# Work Order ID 78702

Item Name: 205 Skidtube bent detail

DRAWING NO. D2580	TITLE 205 SKIDTUBE ASSEMBLY	REV. E	DART AEROSPACE LTD ENGINEERING ORDER		D.E.O. NO. D2580-E-1	SHEET NO. SHEET 1 OF 1	SCALE NTS
DRAWN <i>UP</i>	CHECKED <i>ASS</i>	MFG. APPR. <i>EC</i>	APPROVED <i>[Signature]</i>		DE APPR. <i>[Signature]</i>		
DATE 11.12.13	DATE 11.12.13	DATE 11.12.13	DATE 11.12.13		DATE 11.12.13

CHANGE ALL C'BORED WELDED CROSSBOLT SPACERS TO SWAGED SPACERS

**SECTION B-B, F-F, I-I**  
NOT TO SCALE

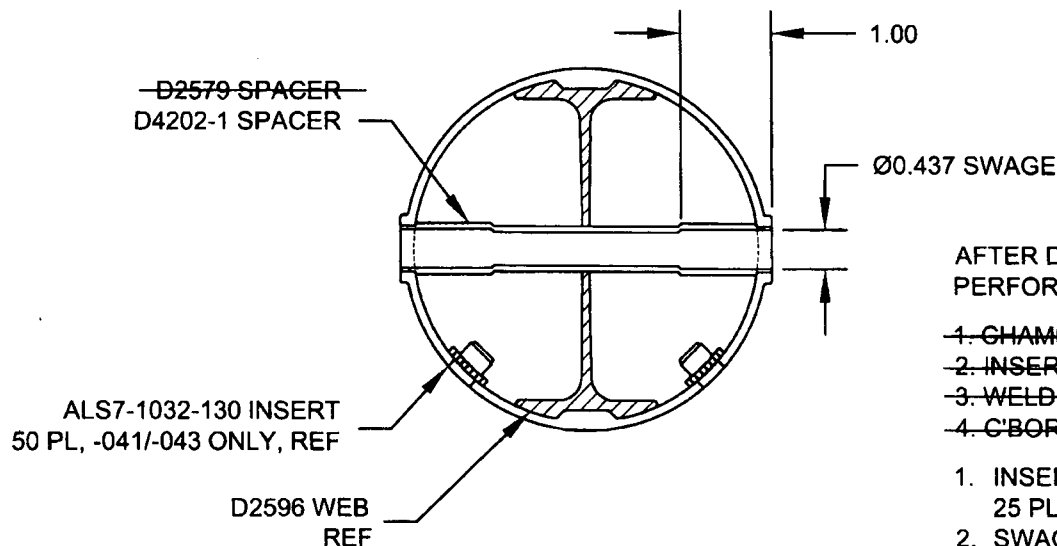
PARTS LIST IS AMENDED AS FOLLOWS:

WAS

QTY	QTY	QTY	PART NUMBER	DESCRIPTION
-041	-045	-047		
20	24	25	D2579	CROSS BOLT SPACER

SECTION B-B, SECTION F-F, & SECTION I-I ARE AMENDED AS FOLLOWS  
FOR ALL HOLES THAT WERE ORIGINALLY C'BORED:

**\* FOR -045 SKIDTUBE ONLY:**  
WELD 4X D2579 SPACERS PER DWG  
IN LOCATIONS MARKED "NO C'BORE".  
REF SHEET 4 OF DWG.

- ~~1. CHAMFER HOLE 0.060 X 45°~~
- ~~2. INSERT D2579 SPACER (20 PLACES)~~
- ~~3. WELD INTO PLACE AND GRIND FLUSH~~
- ~~4. C'BORE D2579 SPACER TO Ø0.437 X 1.00 DEEP~~

4		* D2579	CROSS BOLT SPACER
20	20	25	D4202-1	SPACER

1. INSERT D4202-1 SPACER, 20 PL (-041) OR 20 PL (-045) OR 25 PL (-047)
2. SWAGE TO Ø0.437 X 1.00 DEEP PER QSI 002
3. TRIM / GRIND FLUSH PER QSI 002
